Address: **Glenbriar Maintenance Building**

Permit number: Com19-0012

Second Submittal

Scope of Work: **Maintenance Building Volume 6.**

**Figure 11B-302.3**  
**Elongated Openings in Floor or Ground Surfaces**

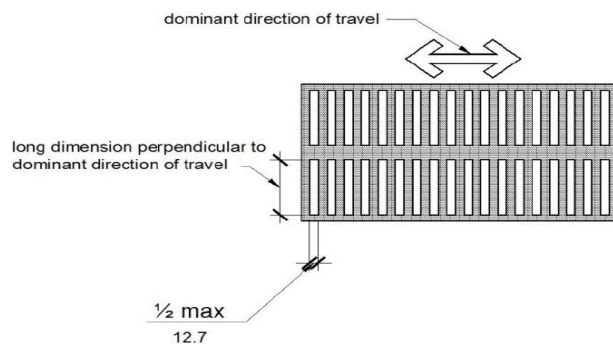
8. Provide a note for all floor surfaces to be non-slip per section 11B-302.1 CBC. Grating & opening along the accessible path of travel comply with 11B-302.3 CBC. **PC.2, see the comment at the foundation and site work portion of this permit.**
